HEARING REPORT

**DRURY ARTERIALS NETWORK NOTICE OF
REQUIREMENTS (D1 – SH 22 UPGRADE)**

VOLUME ONE

WAKA KOTAHI

Figure 7: Except from drawing SGA-DRG-STH-04-CI-3101, showing potential left turn access

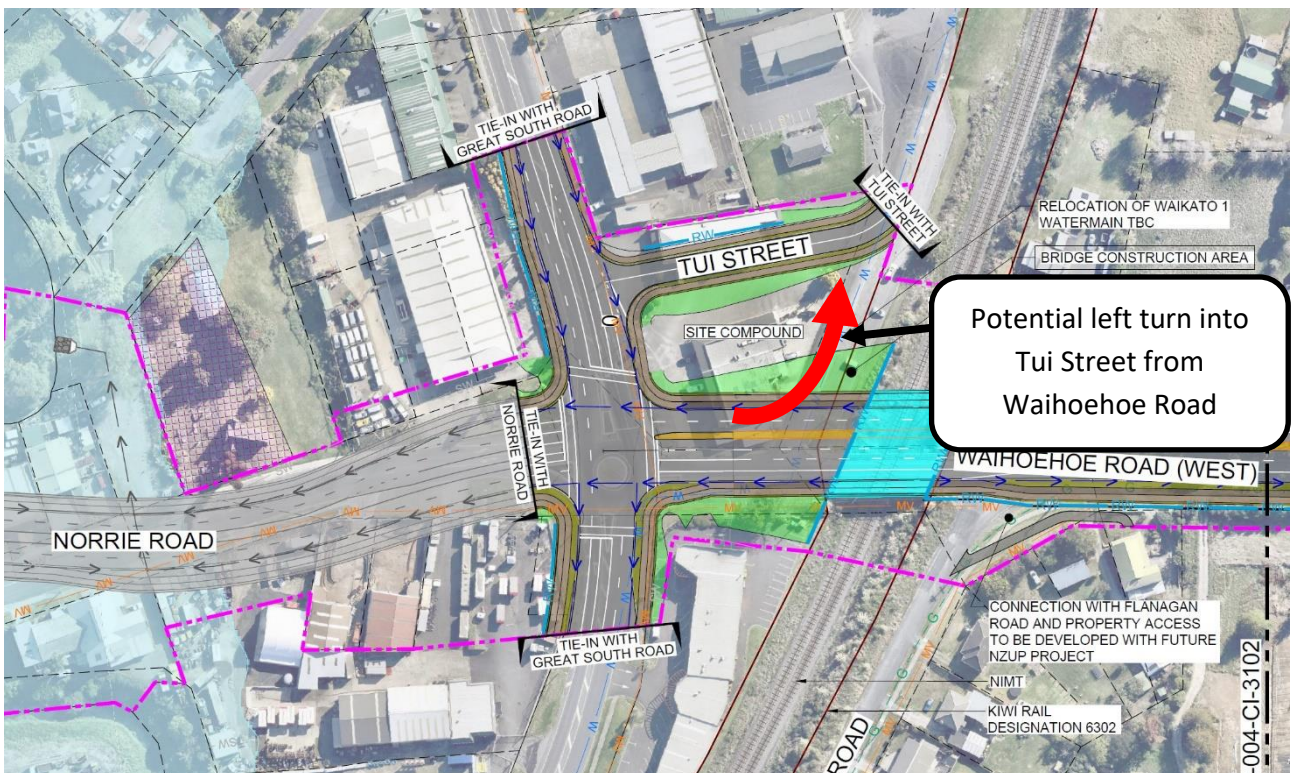
NoR D2 shows the realignment of Tui Street, to form a new intersection with Great South Road as shown in Figure 7. I queried whether the proximity of the proposed intersection with the upgraded Great South Road/Waihoehoe Road intersection (to traffic signals) is likely to create safety issues for drivers turning right into and out of Tui Street. The applicant responded by stating that right turns into and out of Tui Street would be prohibited and that the Project will be subject to a detailed safety audit prior to construction.

I further questioned SG on the access and safety effects of restricting right turns at the proposed Great South Road/Tui Street intersection, as this will result in detours and potentially unsafe u-turn manoeuvres, as drivers arrive from the south and/or depart to the north. In response, SG stated it was investigating whether a left turn into Tui Street could be provided from Waihoehoe Road, which would mitigate effects from prohibiting right turns in from Great South Road, however this would not be included within the NoR drawings. I have indicatively marked this in Figure 7. SG suggested that this matter could be addressed via a condition, which it put forward to Council for consideration.

The Outline Plan shall demonstrate how the realignment of Tui Street provides for safe and legible access for the Drury and Districts Rugby Football and Recreation Club and community facilities ~~using and the use of the Drury Domain from Tui Street and Great South Road and the use of the Drury Domain.~~ This shall include consideration of a left in turn at Waihoehoe Road and confirmation of completion of a safety audit. This shall include the Outline Plan making provision for permanent left turn access from Waihoehoe Road to the realigned Tui Street unless alternative access can be provided and a road safety audit being submitted with the Outline Plan, The road safety audit shall assess the access and safety effects of turning restrictions at the Great South Road/Tui Street intersection, including likely rerouting and potential u-turning movements, and recommend mitigation measures where required, including measures to be implemented as part of the detailed design of the Project.

Figure 8: Alternative location for Drury Domain access and parking

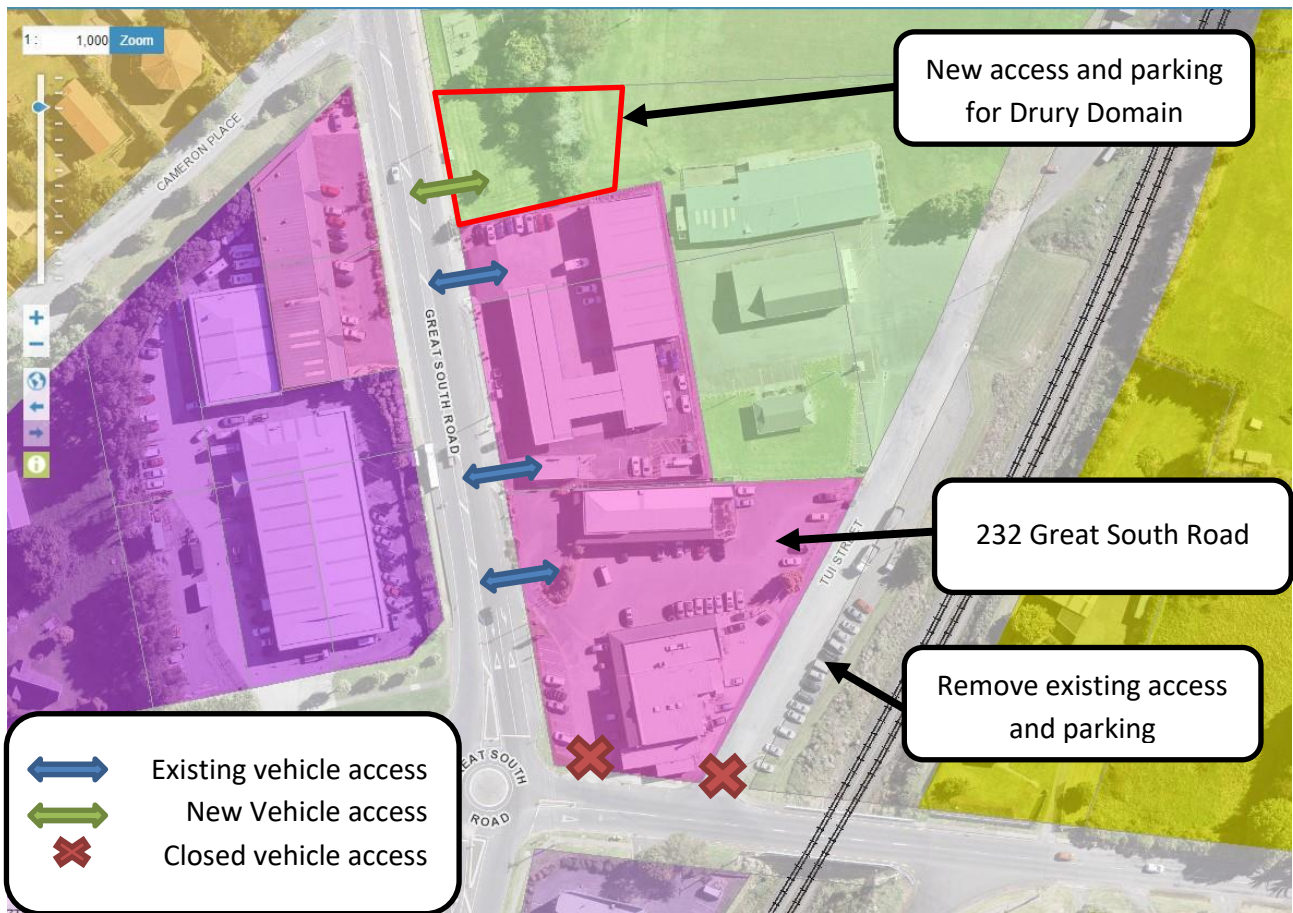
Along with Council Community Facilities staff I investigated whether Tui Street could be closed, and alternative access to Drury Domain could be provided via Great South Road near the Cameron Place intersection with Great South Road, as shown in Figure 8. However, following discussions with Auckland Council Community Facilities staff I understand that relocating the access and parking for Drury Domain to the northern side of the Drury Domain Club Rooms may not be supported.

Figure 9: Intersection of Drury Hills Road and Waihoehoe Road, from drawing SGA-DRG-STH-004-CI-4103

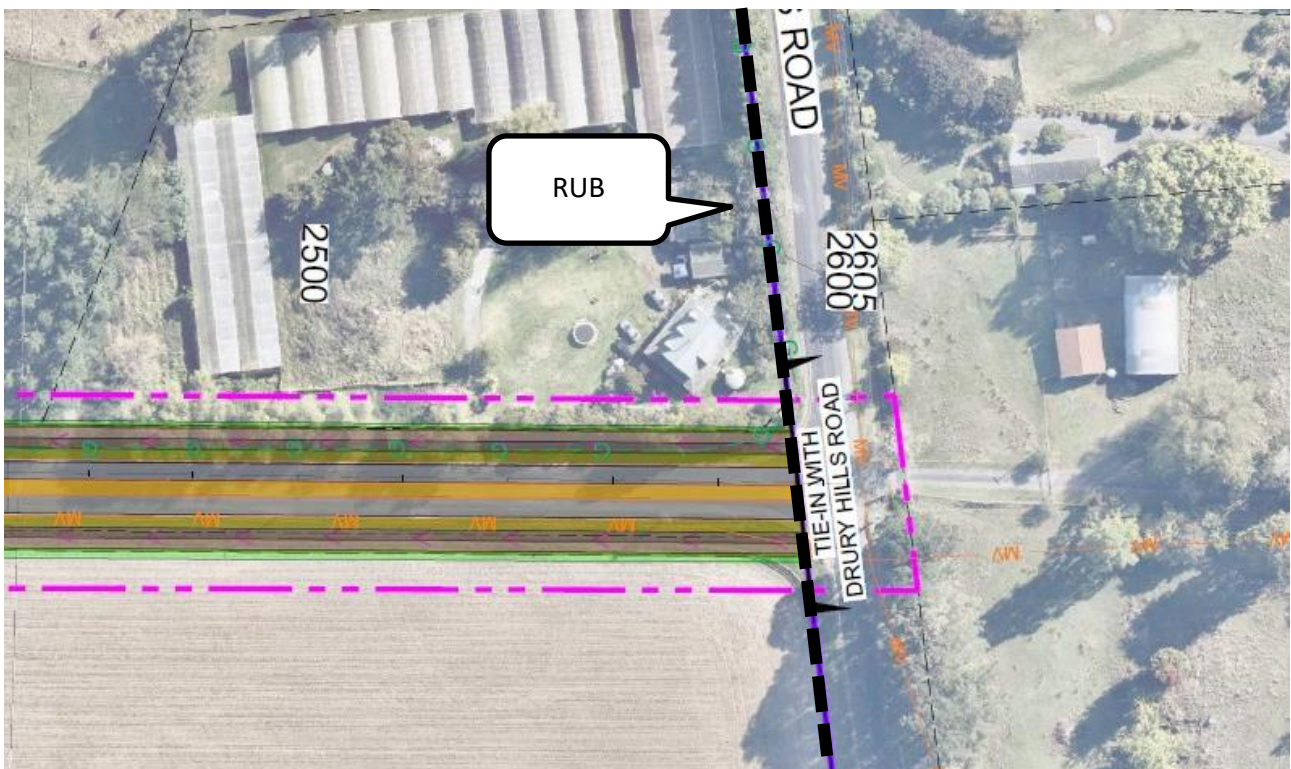
I queried with SG whether a safe transition between an urbanised arterial (NoR D3) and a rural local road (Drury Hills Road) could be accommodated within the proposed designation boundary and/or the existing legal road boundary. As shown in Figure 9, Drawing SGA-DRG-STH-004-CI-4103 does not include an appropriate tie in to Drury Hills Road. I consider that this is particularly relevant given the deferral of funding for Mill Road (which is assumed to be along Drury Hills Road for this section of the Mill Road project).

Outcome: No further action is required as part of the NoR.

Figure 10: Indicative design for NoR D3/Waihoehoe Road/Drury Hills Road intersection⁶

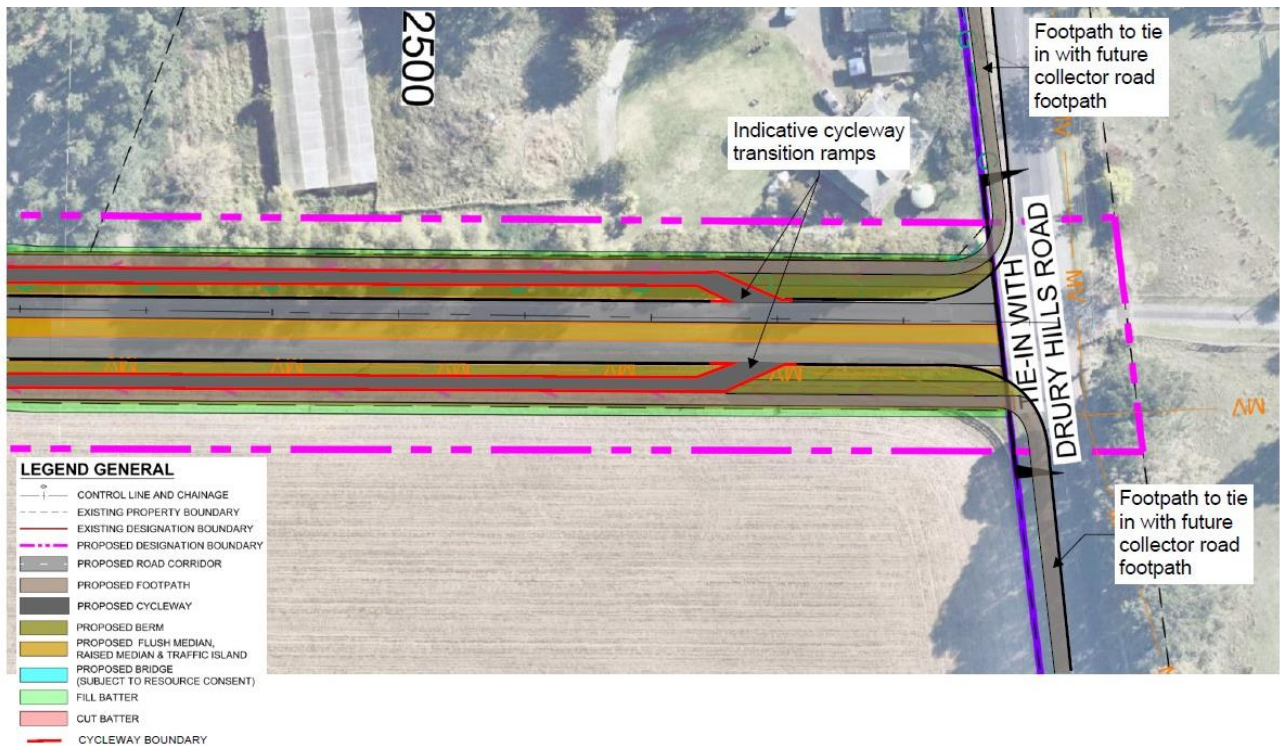
In response to my further query, SG provided an indicative intersection design to demonstrate how the transition might be constructed (shown in Figure 10). I consider that this conceptual design demonstrates that there is sufficient space to accommodate the intersection and transition, and that the actual arrangement can be determined during the future OPW.

Figure 11: Intersection of Ponga Road and Jack Paterson Road, from drawing SGA-DRG-STH-04-CI-8102

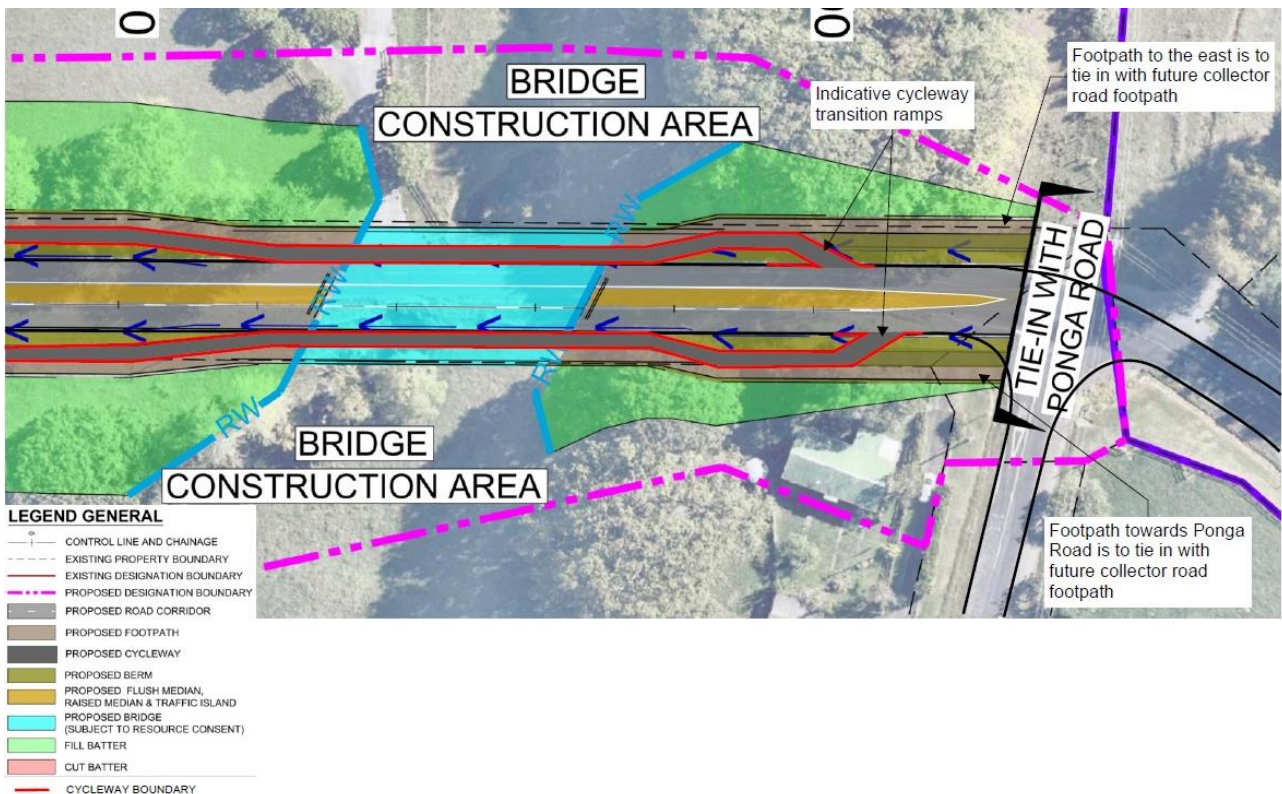
I queried with SG whether a safe transition between an urbanised arterial (NoR D5) and a rural local road (Ponga Road and Jack Paterson Road), could be accommodated within the proposed designation boundary and/or the existing legal road boundary. As shown in Figure 11, Drawing SGA-DRG-STH-004-CI-8102 does not include an appropriate tie in to Ponga Road.

In response to my further query, SG provided an indicative intersection design to demonstrate how the transition might be constructed (shown in Figure 12). I consider that this conceptual design demonstrates that there is sufficient space to accommodate the intersection and transition, and that the actual arrangement can be determined during the future OPW.

Figure 7: “Option B1” reproduced from Appendix A – Assessment of Alternatives – Figure 11.17

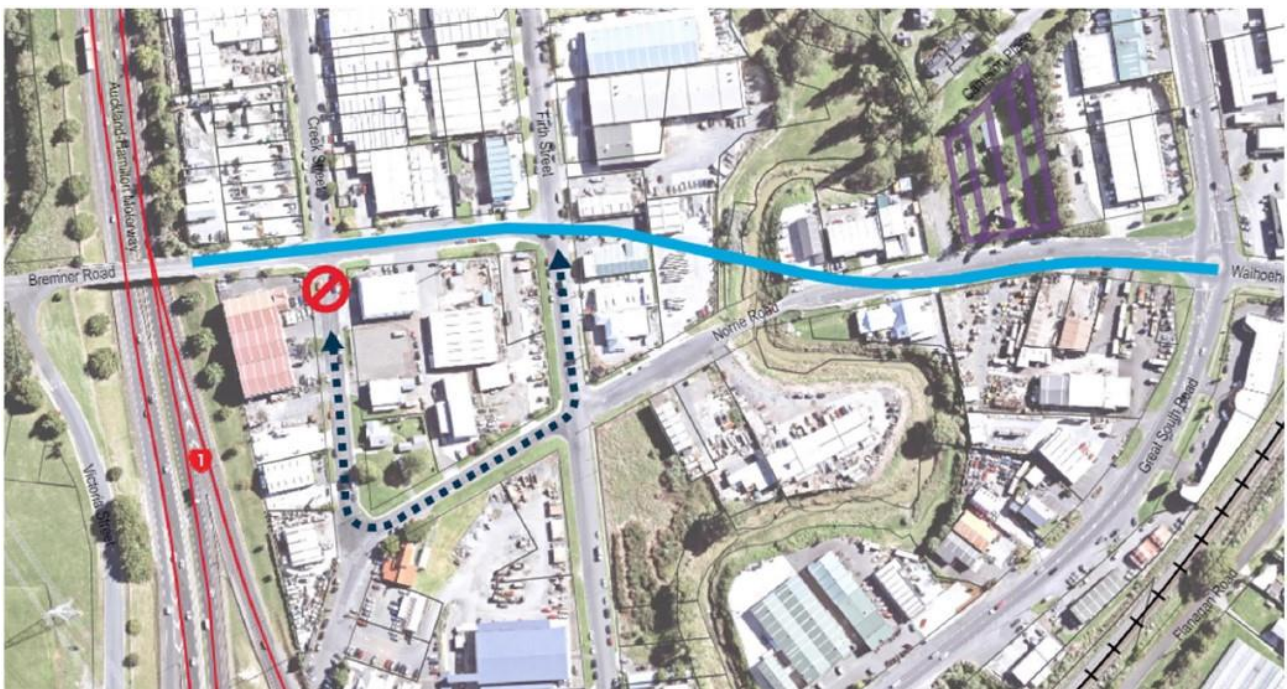
Section 11.2.4 of Appendix A – Assessment of Alternatives details several options that were considered for the alignment of the Bremner Road FTN through the existing urban area of Drury Village, with Option B1, which is shown in Figure 7, being carried through to NoR D2.

Speculative fact 1: the application documents do not provide sufficient evidence to support Norrie Road realignment Option B1 on the grounds of transport benefit and land take effects.

Figure 8: “Option A” reproduced from Appendix A – Assessment of Alternatives – Figure 11.10

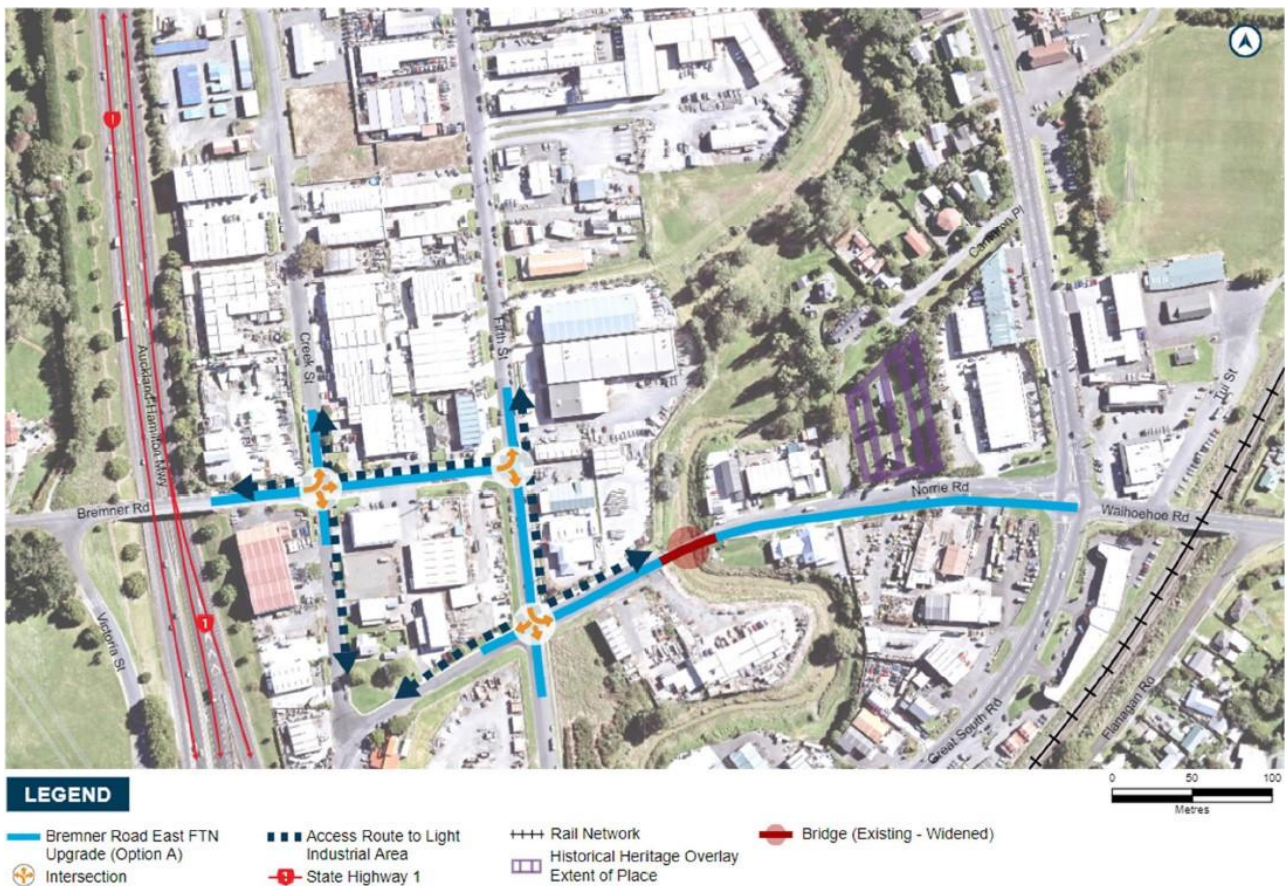
Option A, which is shown below in Figure 8, was discounted for a variety of reasons (detailed in Table 11-12 of Appendix A – Assessment of Alternatives), including perceived congestion effects and it having similar effects on existing businesses compared with Option B1.

Figure 9: Assumed road connection through live zoned industrial land

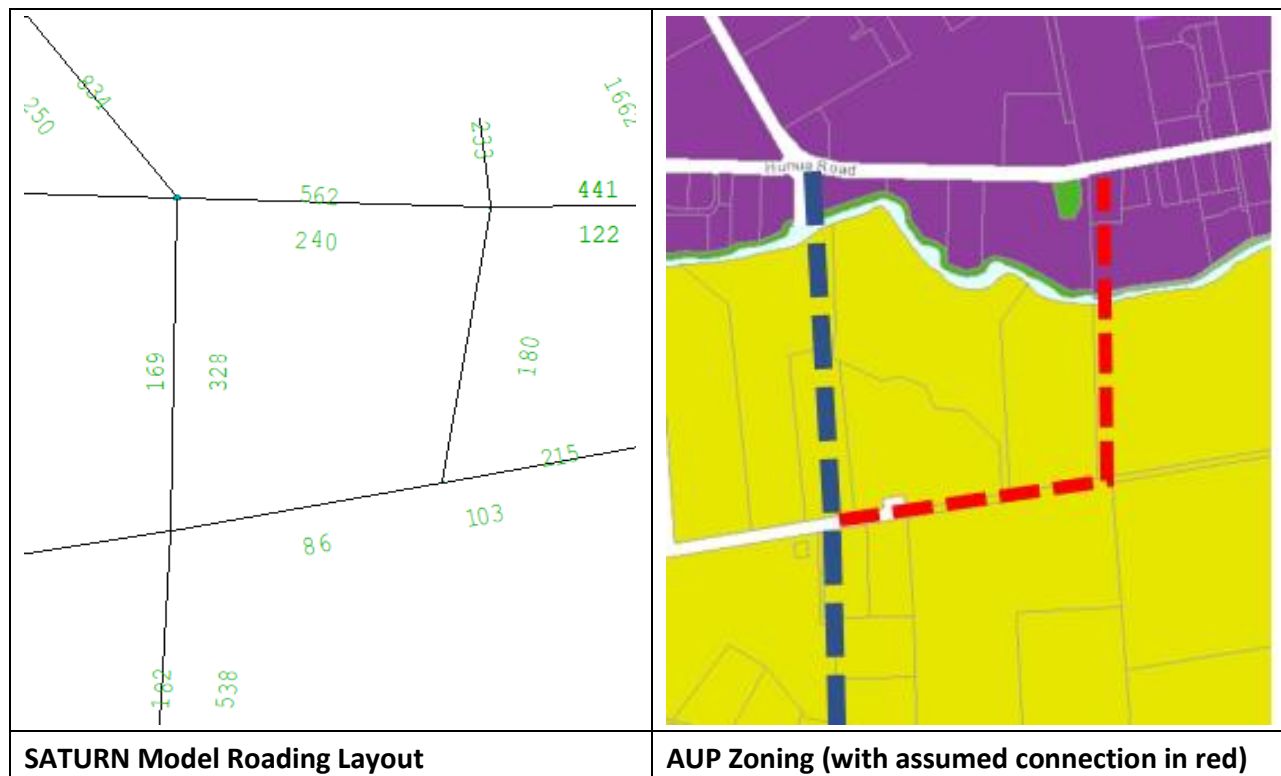
The traffic model includes future roads which feature in the Drury-Ōpāheke Structure Plan. While new roads located within the Future Urban Zone can be considered likely, the traffic model includes a new road, south of Hunua Road which connects to NOR D4 (as shown in Figure 9).

We query whether it is feasible to include a future road that passes through live zoned industrial land that would require a designation to enable construction. The road carries some 200 vehicles per hour, which is a reasonable increase in demand. While the midblock design of NoR D4 (approaching Hunua Road) would allow for this increase in demand, we query whether the designation about the intersection of NOR D4/Hunua Road has a sufficient envelope to allow for what may be a slightly higher traffic demand when catering a higher flow should the road assumed through live zoned land not exist in the future.

Figure 11: Intersection of Waihoehoe Road and Flanagan Road, from drawing SGA-DRG-STH-04-CI-3101

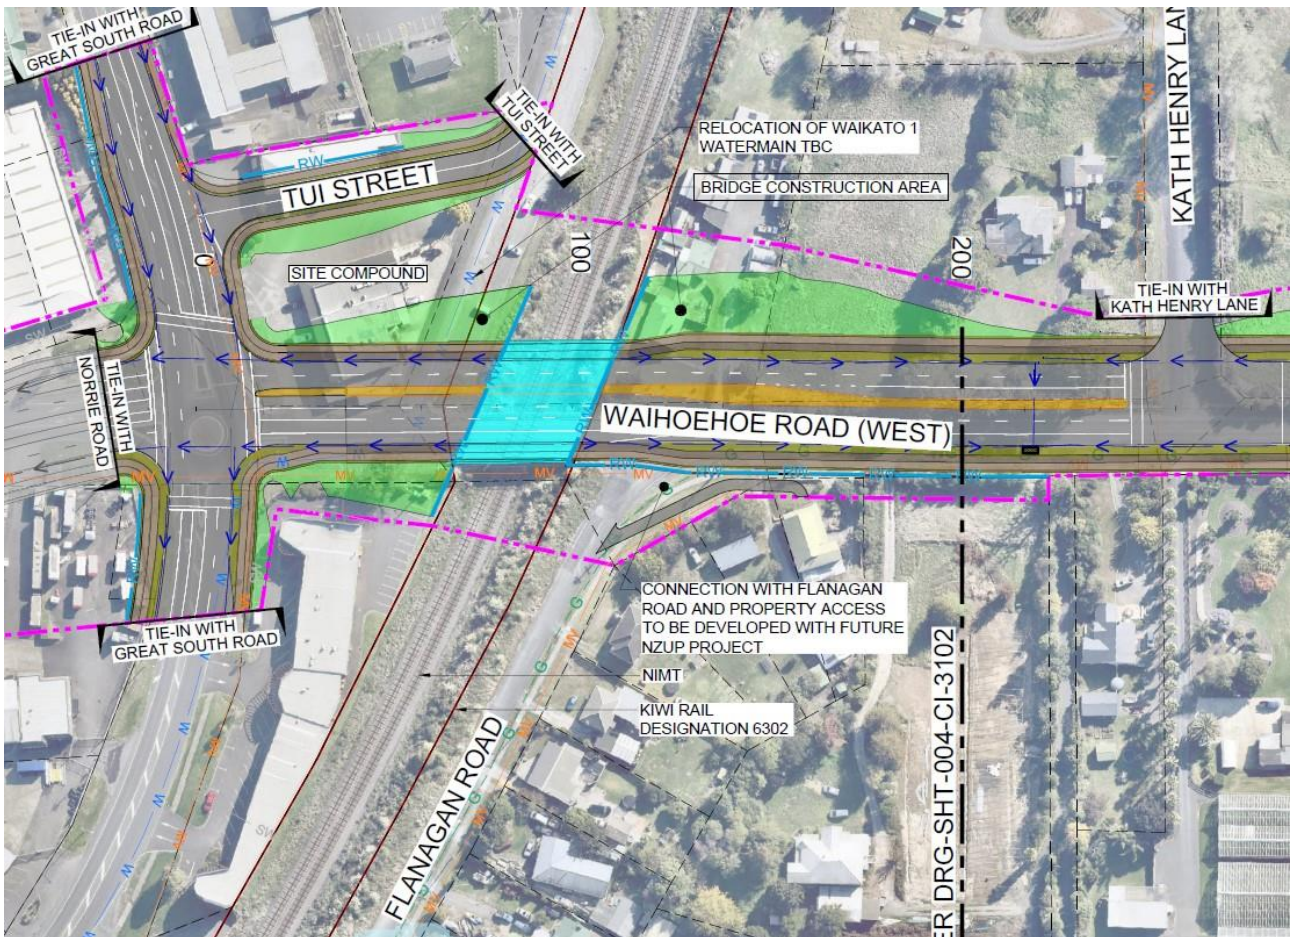
In our view NoR D2 should not include the closure of the Flanagan Road intersection, as currently shown in Drawing SGA-DRG-STH-04-CI-3101. If the closure of the intersection proceeds works under NZUP, this affect access to the future rail station and existing properties on Flanagan Road, noting there is currently no alternative access for Flanagan Road.

Inadequate level of detail 3: Please provide further detail on the proposed closure of the Waihoehoe/Flanagan intersection, including timing, co-ordination with any other works needed to maintain access to Flanagan Road, and consultation with affected parties. Alternatively, if the closure of the intersection is not proposed as part of the designation, drawing SGA-DRG-STH-04-CI-3101 should be updated.

Drawing SGA-DRG-STH-04-CI-3101 shows the realignment of Tui Street, to form a new intersection with Great South Road, as shown in Figure 11 above. We consider that the proximity of the proposed intersection with the upgraded Great South Road/Waihoehoe Road intersection is likely to create safety issues for drivers turning right into and out of Tui Street. Please provide further assessment of the proposed realignment of Tui Street, including safety and access effects, and comment on what means to mitigate potential safety effects were considered (such as an alternative access to the north of the Drury Rugby Clubrooms).
